CITY PLANNING COMMISSION

APPLICATION: Special Permit to develop a residential care facility for 10 elderly persons.

LOCATION: 7415 Henrietta Drive

Site Plan
1" = 40 Feet

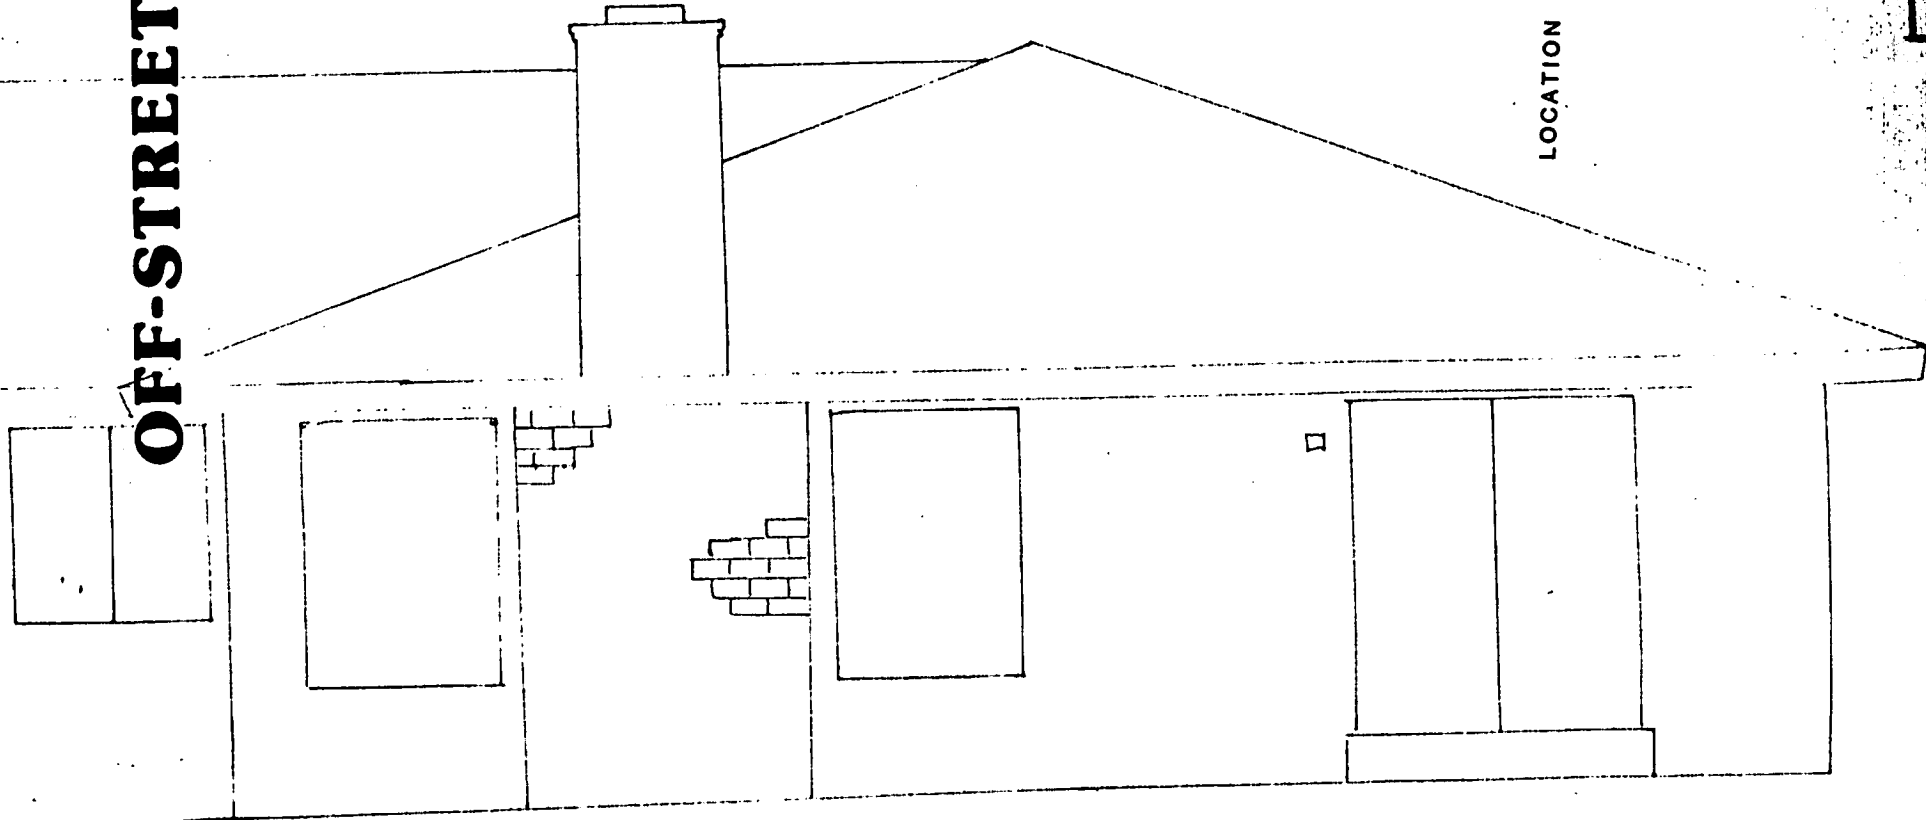
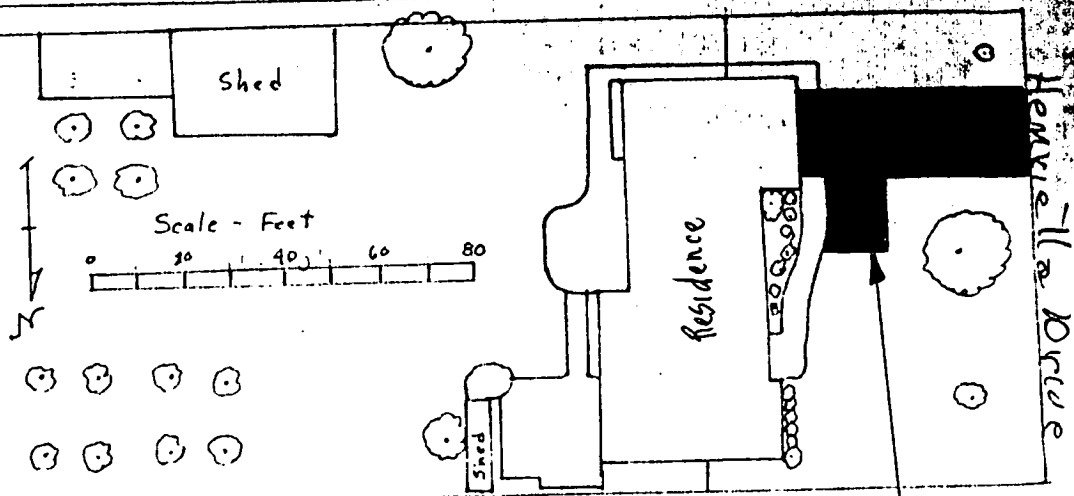
- e. Parking: The criteria specifies that adequate off-street parking be provided for staff, clients and visitors. The plans do not indicate the location of off-street parking spaces, the size of the spaces, or the number of spaces to be provided. The Zoning Ordinance requires that the Planning Commission determine the number of parking spaces for care facilities.

The applicant has stated that five spaces can be located in the existing driveway area and that they anticipate few visitors since all patients are ambulatory. A field evaluation of the site does confirm the fact that a large parking area does exist in front of the residence which would require backing out into the street. The parking area could accommodate employee parking and any additional visitor parking. Since it is unlikely that a great number of visitors would be expected at any one time, staff considers parking to be adequate and compatible with the surrounding neighborhood.

FLOOR PLAN
7415 HENRIETTA DR.
APN 048-052-03
PROPOSED CHANGES
SCALE 1/4 IN. = 1 FOOT

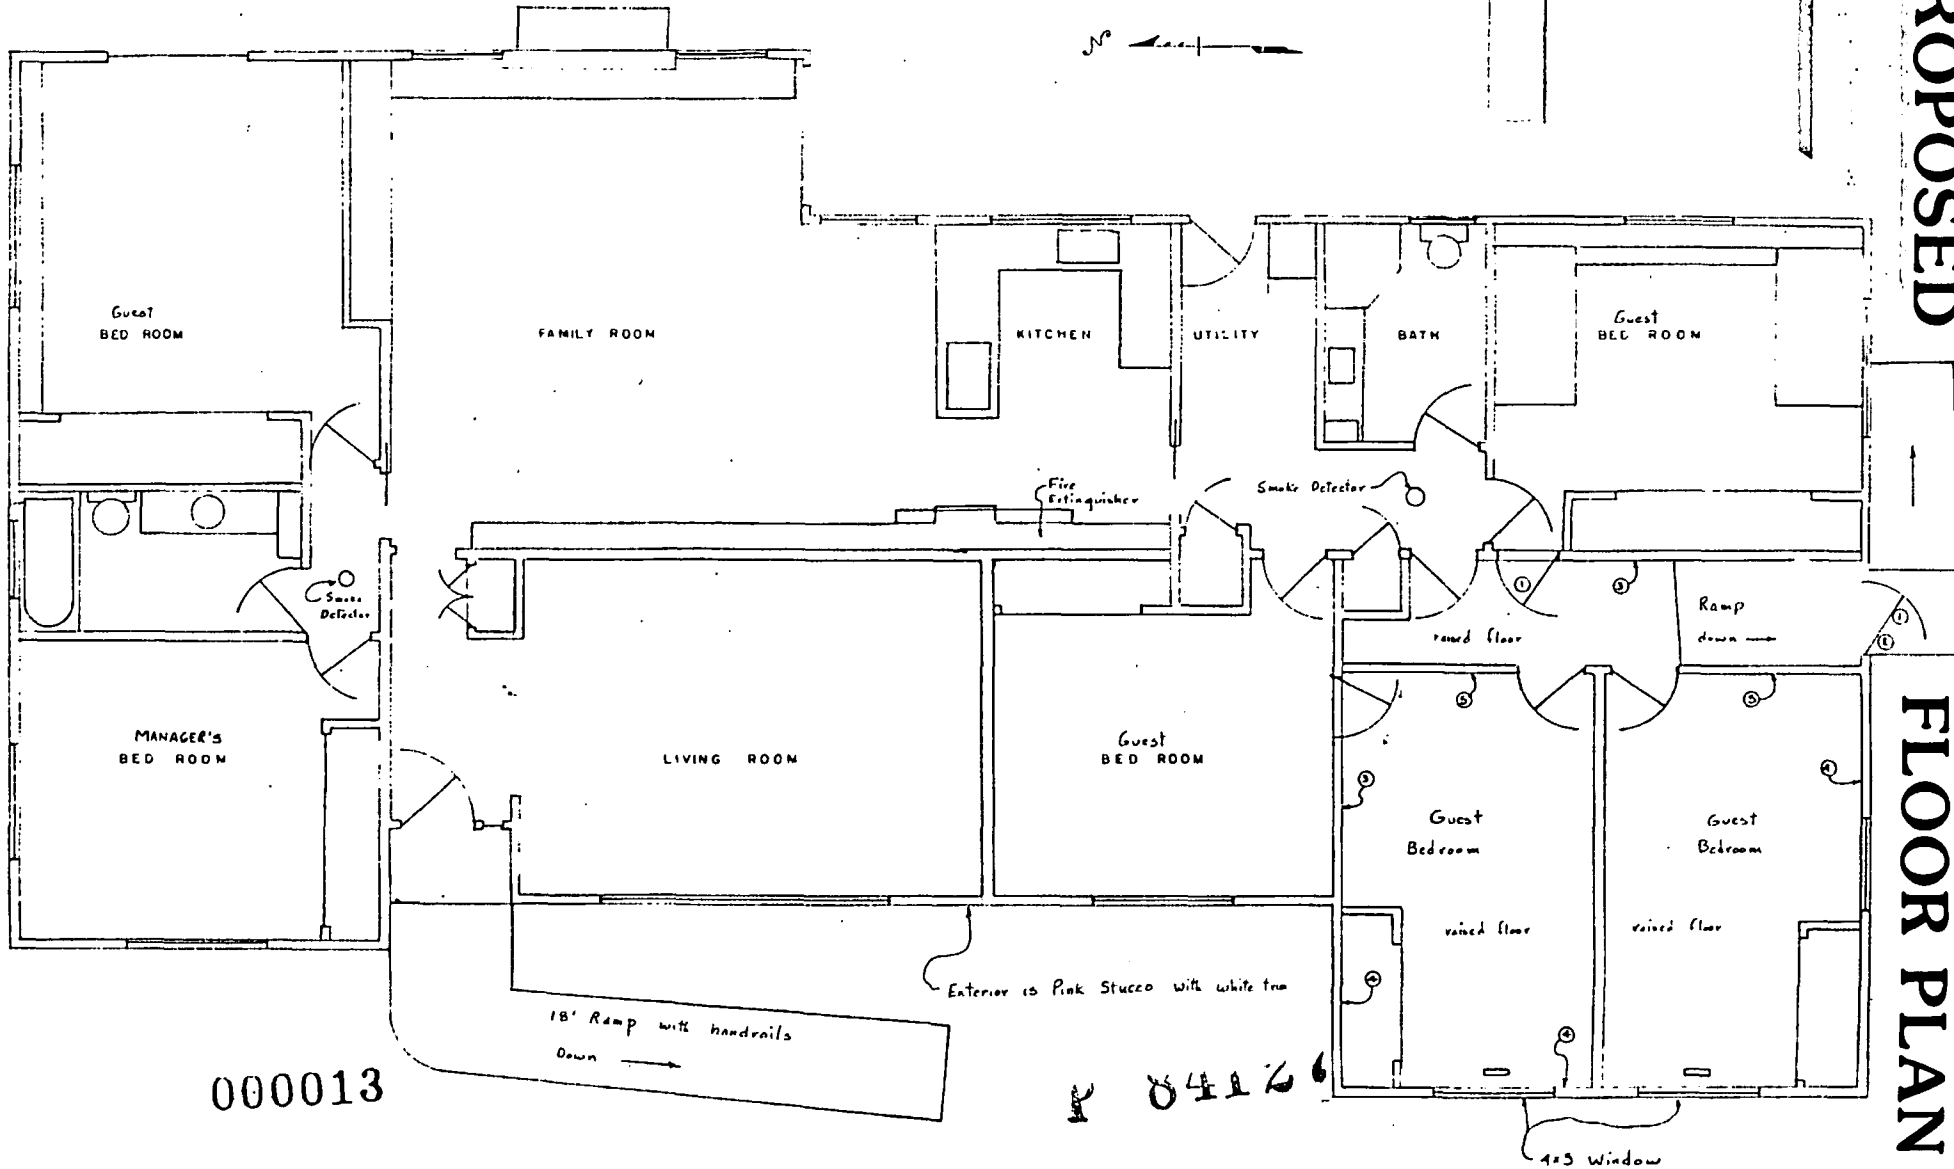
- c. Size of Structure: The plans indicate that the existing structure will undergo interior remodeling to accommodate the anticipated number of clients and employees. In accordance with Building and Fire regulations, the structure will be required to provide handicapped access points and fire suppression systems. Adequate outdoor areas for client use are available; however, it is unclear as to what extent this area will be used since all patients are ambulatory.

- a. All remodeling shall be subject to review and approval by the Fire and Building Inspections Departments;
- b. The care facility shall be limited to 10 elderly persons.
